Masihata Sweaters Ltd (9506)

09.April.2014

Identified Priority 1 Concerns

Manufacturing building –
columns do not match documentation provided; loading to
be reduced to acceptable stress level

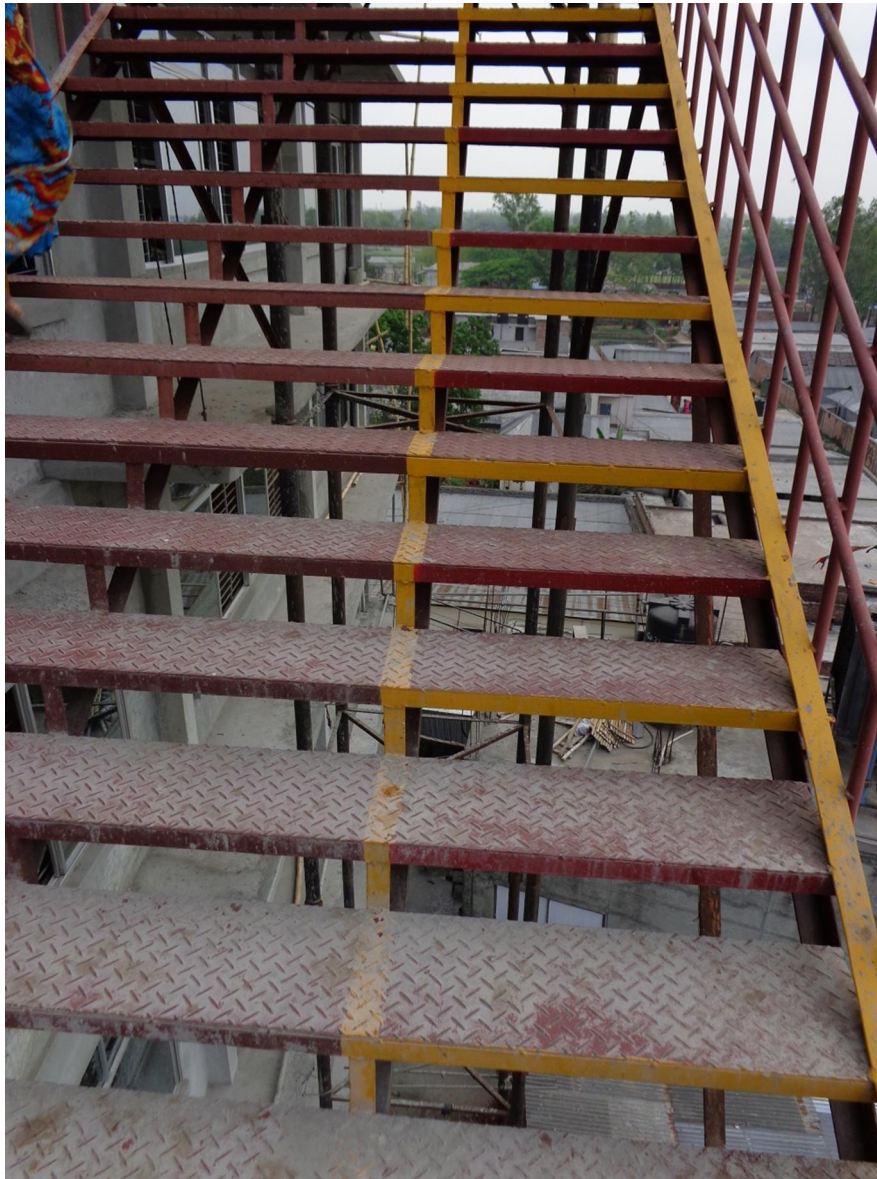
Built in 2002 with brick stone chips , rebar strength was not provided (40ksi assumed)

Column does not reflect information provided on structural drawings which indicated 500mm dia. column with 22-20mm bars.

We surveyed a 450mm dia .column with 14-20mm bars . Two columns were Ferroscored.

Loading on typical column reflects approx 2 kPa, except in one sector where washing machines and other manufacturing equipment may be closer to 3 kPa (min). High brick partitions with plaster on both sides are also found at midspan in certain areas of building

Action is to be taken to reduce loads (Action section)

Reduce loading on columns to acceptable stress level

- the first floor & two others need to be closed down, another floor's load needs to be reduced to just below 2.0kPa and the 5th floor needs to be restricted to no more than 2.0kPa
- Verify in-situ stress and material properties by testing 100mm dia. Concrete cores of 4 columns
